**CCB 7607**  
**Pre and Post Change Summary**  
**PCN #: MFOL-22LPPO809**

# Lead-Frame Comparison

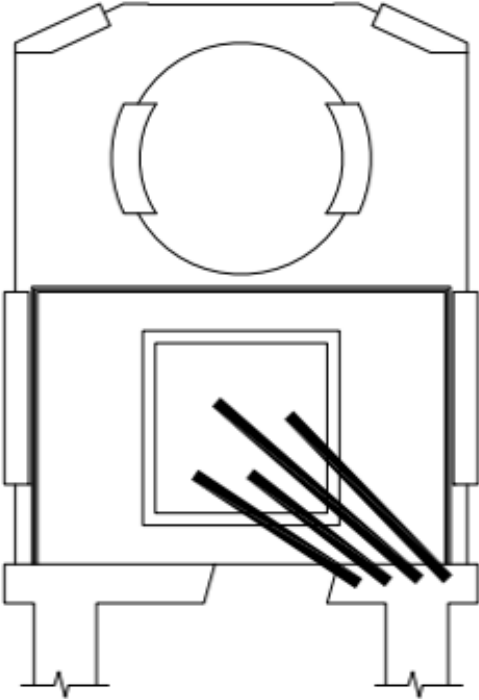
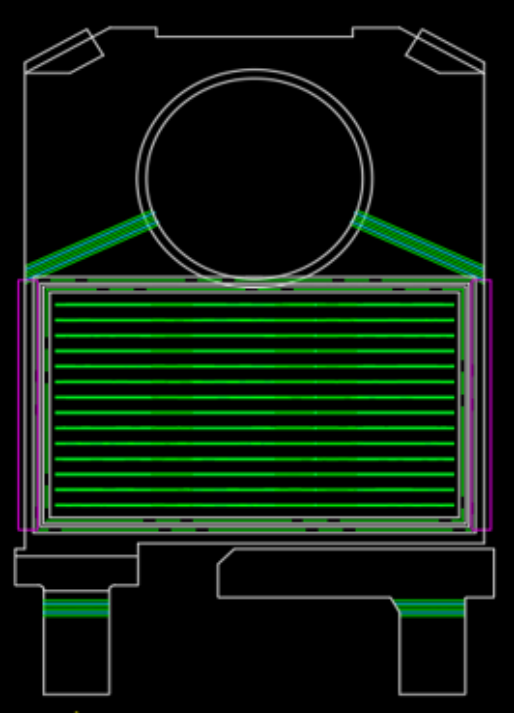
FSTS		ASEW	
 <p>Note: Not-to-scale</p>		 <p><i>Mold locking grooves (Lead lock)</i></p> <p>Note: Not-to-scale</p>	
Lead-Frame Lead-lock	No	Lead-Frame Lead-lock	Yes
